CABINET MEMBER FOR ENVIRONMENT – 21 MAY 2020

OXFORD MORRELL AVENUE PROPOSED ZEBRA CROSSING

Report by Interim Director of Community Operations

MORRELL AVENUE, OXFORD
 EASTERN MORRELL AVENUE
 CROSSING OPTION 11

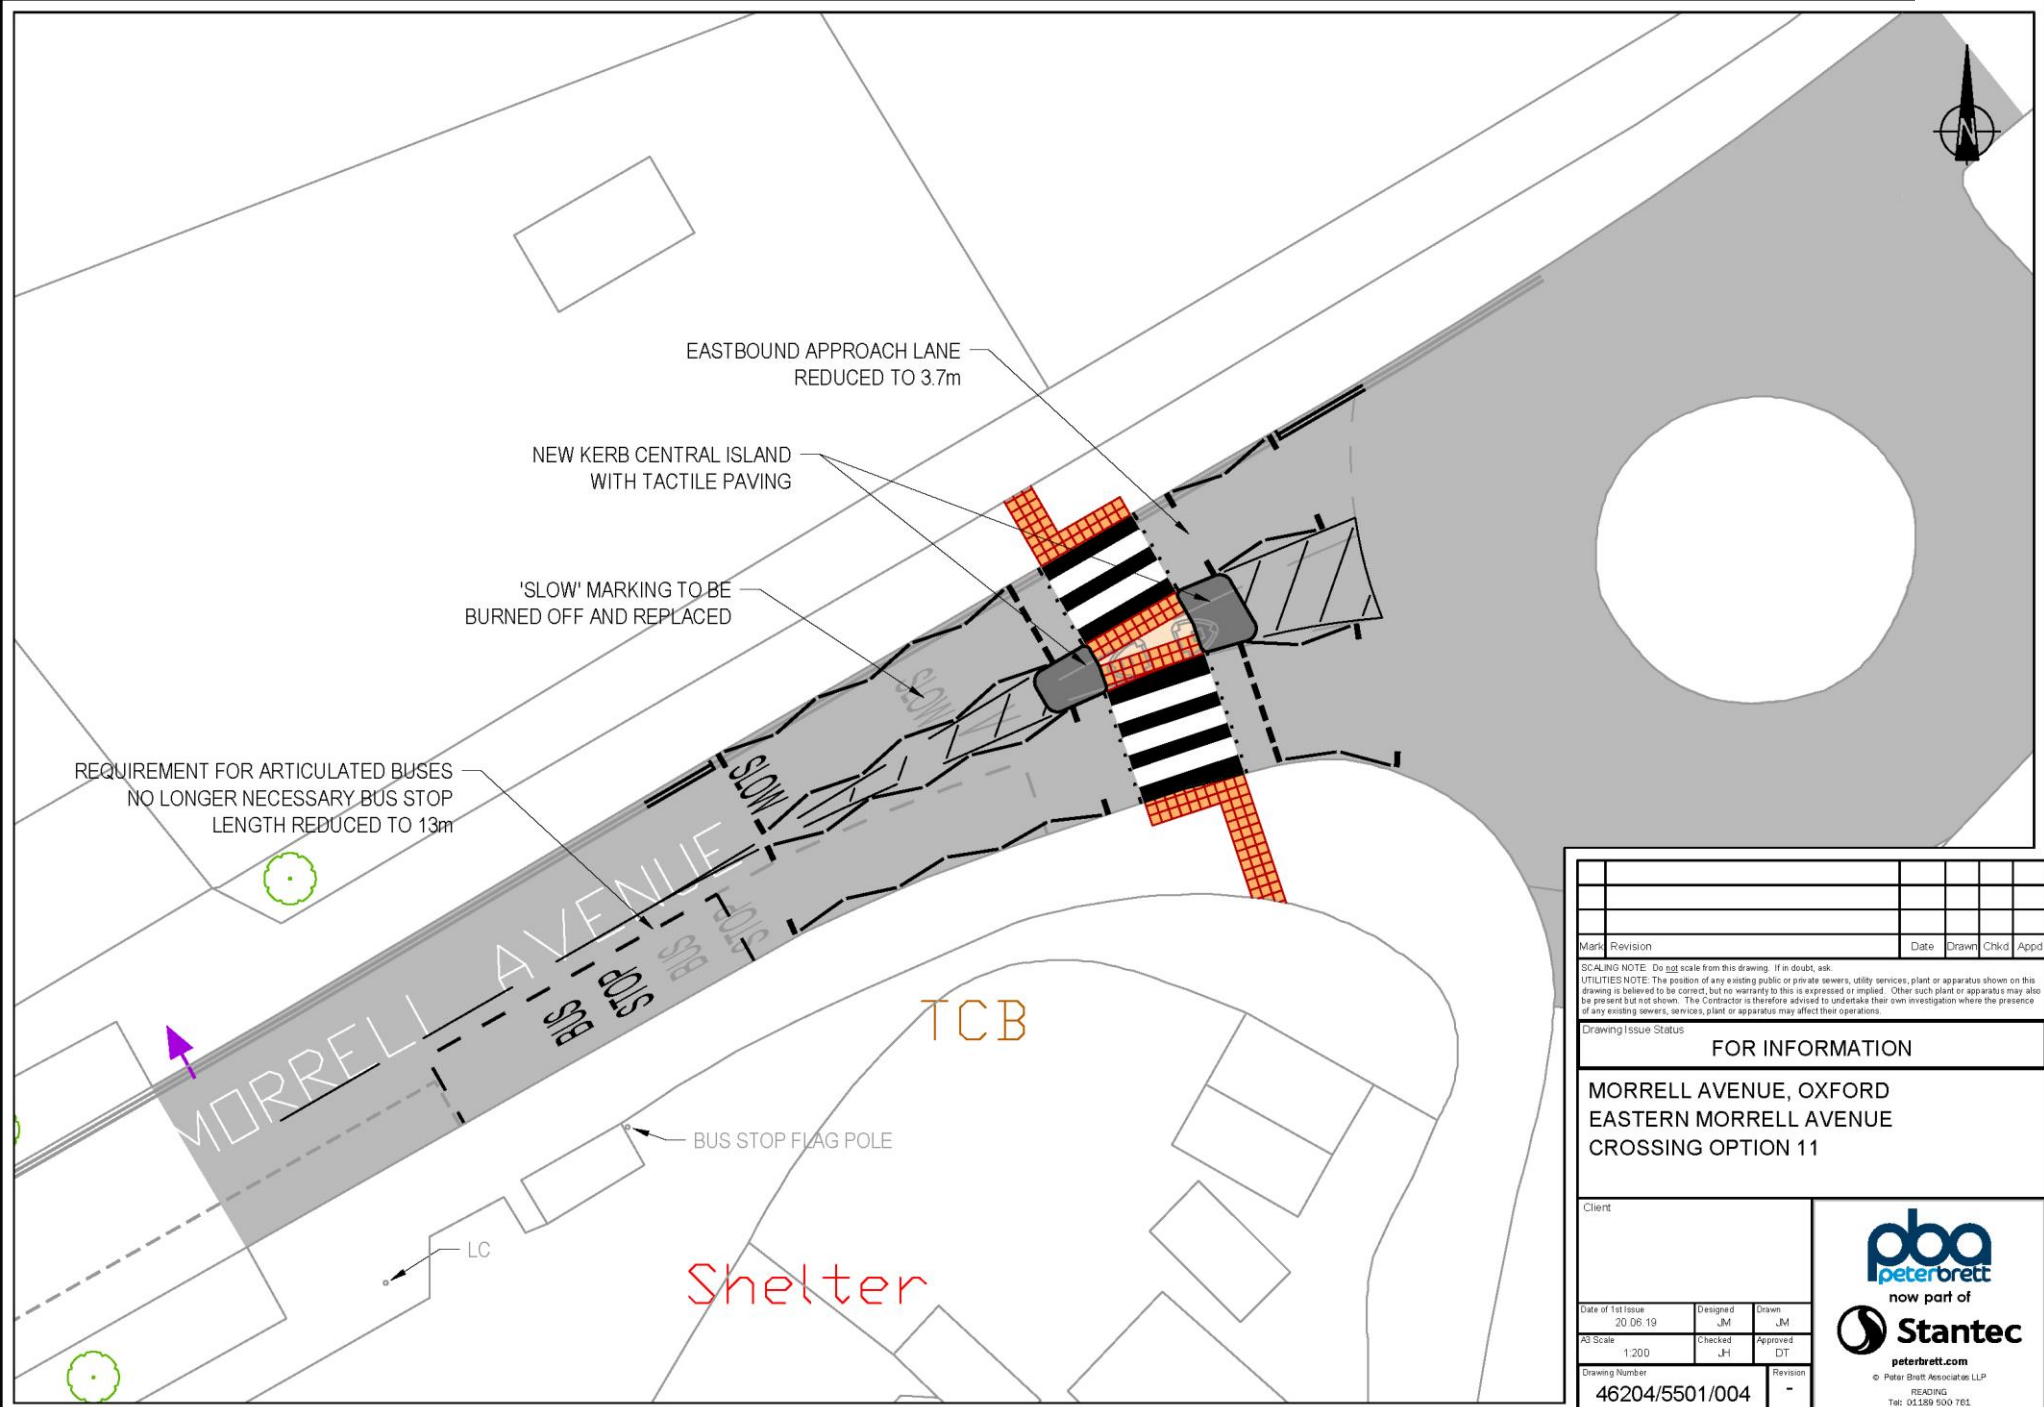
8. Thames Valley Police have not objected to the proposal but noted that an adjustment needed to be made to the position of a road marking to ensure full compliance with national regulations on the layout of pedestrian crossings. That adjustment will be made.

9. Cyclox, a local group representing pedal cyclists in Oxford, while not objecting in principle to the crossing nevertheless objected to its design in respect of the width of the traffic lane (3.5 metres) on either side of the central island for the crossing, citing guidance issued by Transport for London in respect of lane widths, which recommends that lane widths of between 3.2m and 4.0m should be avoided to avoid ambiguity on whether there is sufficient space for motor vehicles to overtake a pedal cyclist. While noting this comment, specifically in the context of appropriate widths at pedestrian refuges and traffic islands, national guidance on designing for pedal cyclists issued by the Department for Transport does not flag the proposed 3.5m width as being hazardous and experience of a large number of pedestrian refuges etc. with similar lane widths as those proposed here does not show safety problems with this dimension.

11. Two of the objections cited a concern that the proposed siting of the crossing was hazardous given its proximity to the roundabout and would be counter-productive in respect of safety and also that the crossing was not on the main desire line for pedestrians, particularly for pedestrians walking to and from Divinity Road. The other objections also raised concerns that the crossing was in the wrong location and that providing a crossing further down Morrell Avenue would be preferable, noting also significant concerns over the speed of many vehicles on Morrell Avenue.

RESPONDENT	SUMMARISED COMMENTS
(1) Traffic Management Officer, (Thames Valley Police)	<p>No objection – In principle I have no objection providing the necessary speed motoring has taken place and the result support such a crossing at this location.</p> <p>The design meets current standards. It appears from the drawing the SLOW marking is shown within the controlled area despite having been relocated. I do not believe the regulations permit this and ask that it is located outside.</p>

(2) Local Group, (Cyclox, Cycling UK)	<p>Object - I don't object to the crossing per se. I object to the design width on one side. The design width where traffic exits the roundabout is OK.</p> <p>I object to the width of the road narrowing for traffic entering the roundabout. A traffic island narrowing should be either so narrow that it is obvious that motor vehicles cannot over take a cycle in the narrowing, OR it should be so wide a motor vehicle can pass a cycle in the narrowing. In general this means narrowings NOT BETWEEN 3m and 4m in width. The narrowing in your design is 3.5m which can result in dangerous close passing of cycle users. This side needs to be made wider or narrower for the safety of cycle users. I doubt you can move the central island over due to swept path tracking from Divinity Road.</p> <p>This page from the London standard: "4.4.2 Traffic lane widths Where cyclists are using a lane (bus lanes or general traffic lanes), either Enough space needs to be provided for a motorised vehicle and a cyclist to pass one another comfortably (with 1 metre clearance in areas with a 20mph limit and 1.4 metres clearance where speeds are higher), or The lane should be so narrow that overtaking is not possible. The rule-of-thumb is to avoid situations where motorised vehicles and cyclists are expected to move together through a width between 3.2 metres and 4 metres. Where lane widths are between these two dimensions, there is uncertainty about space for overtaking and a high risk that other vehicles will seek to pass cyclists too closely thereby putting the more vulnerable road user at risk. This includes the typical lane width adopted in much UK practice of 3.65 metres. Use of this lane width should be avoided.</p>

(5) Local Resident, (Oxford)	<p>Object - Having the crossing so close to the roundabout is dangerous as drivers coming around the corner may not realise it is there causing a hazard to people using the crossing. IF they have to brake suddenly to avoid pedestrians that is likely to cause collisions. Most people crossing the path to Brookes cross over higher up, across the central reservation in Warneford Lane as can be seen by the wear on the grass.. They are unlikely to double back to use a crossing.</p> <p>There is a perfectly suitable traffic island already on the site of the proposed crossing.</p> <p>The zebra crossing is supposed to address residents' concerns about speeding in Morrell Avenue. I am not convinced that a zebra crossing at the top of the hill will have any impact on traffic speed down the hill. The only way to slow traffic down is to install a speed camera - the current flashing 20 signs have no effect whatsoever.</p> <p>The decision to install a zebra crossing seems to be a political decision rather than one based on accident data. I think it will make accidents more likely than less and not address the main concern which is the speed of the traffic. If a pedestrian crossing is thought necessary then it should be one controlled by traffic lights. The current proposal seems to be a way of addressing residents' legitimate concerns on the cheap and not solving the underlying problem.</p>

<p>(9) Local Resident, (Oxford)</p>	<p>Concerns - Looking at the plans it seems that its likely to cause some traffic hold ups being so close to the roundabout, can I suggest that a layby created for the bus stop ,there is ample room for it to be moved away from the proposed new crossing.</p>
<p>(10) Local Resident, (Oxford)</p>	<p>Support – We are very much in favour of this since we have young children and there is no safe place to cross currently.</p>
<p>(11) Local Resident, (Oxford)</p>	<p>Support – We live on the upper part of Morrell Avenue and are delighted that a crossing will be built as indicated on the back of your letter to residents.</p> <p>Despite the 20mph limit on the road, the traffic flow and speeds (particularly after the evening rush-hour), make crossing in this location hazardous (although the location is currently by far the safest point to cross - particularly at night). The significant flow to and through the top of South Park by pupils of Cheney School, Brookes students, local residents, dog-walkers, and families visiting the very successful play area, will all be able to cross with less hazard and more comfort if these proposals are speedily realised!</p>

<p>(12) Local Resident, (Oxford)</p>	<p>Support - Please could the design be amended to incorporate provision for cyclists to cross the road here so that they can access the Divinity Road/ Hill Top Road cycle route from the park?</p>
<p>(13) Local Resident, (Oxford)</p>	<p>Support – Fully support.</p>
<p>(14) Local Resident, (Oxford)</p>	<p>Support – <i>No comments.</i></p>

12. In respect of the concerns over the safety of the crossing, particularly in relation to its proximity to the roundabout, its layout (as noted in the police comment) does comply with national guidance and there are examples in Oxfordshire of crossings similarly sited close to roundabouts which have good safety records. An independent road safety audit of the design has also been carried out.

13. While noting the concerns that the crossing is not on the main desire line for pedestrians and that a crossing elsewhere on Morrell Avenue is needed, the crossing has been designed by Oxford City Council in response to representations made by elected members based on their understanding of the needs of pedestrians in this area.

15. Expressions of support were received from five members of the public; one of these requested that the layout be amended to allow cyclists to also cross the road here. Noting the latter comment, dismounted cyclists will be able to use the crossing and, while not ruling out the future upgrading of the crossing to a parallel crossing for use by both pedestrians and cyclists (with linking shared use footways), this is beyond the scope of the current project.
